SURVEY OF WATSON LIBRARY FOR COMPLIANCE WITH "AMERICANS WITH DISABILITIES" ACT

Jl 26th 1990

DOORS

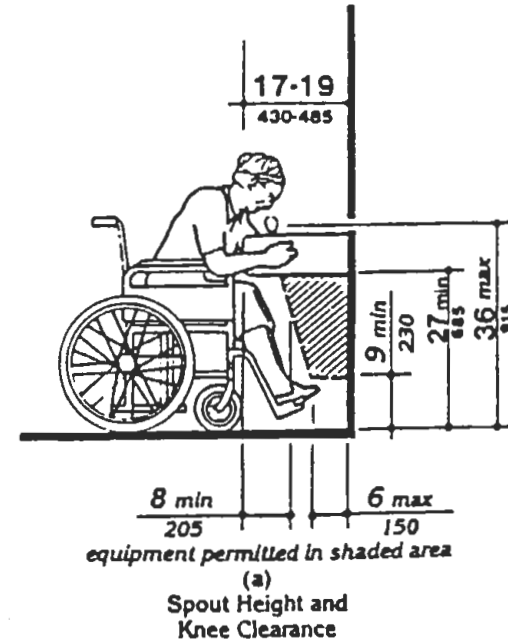
- 5) The problem with our doors is getting into the library. All our external doors open to the outside, and it is obviously very difficult for someone in a wheelchair to try and hold a door open with one arm and propel a wheelchair into the interior. Wheelchairs equipped with battery-powered motors have an advantage over non-powered wheelchairs. The same situation applies to the doorways providing access to the general stacks on the second and third floors. Getting out of the library is less difficult, especially if one has a powered wheelchair. Individuals sort of bull their way through by using their wheelchair to butt the doors open.

It is my personal opinion that, out of a sense of simple consideration if nothing else, we ought to have electric door openers for the handicapped at selected doors. I have seen these, and I have tried to make an illustration below.

By pulling the trigger an electric motor pulls the door away from the handicapped person. The door closer can be set to allow 10-15 seconds clear time before starting to close (we need to have these adjusted anyway, since presently they do not appear to hold any door open).

Sticks out about 15" from the door facing.
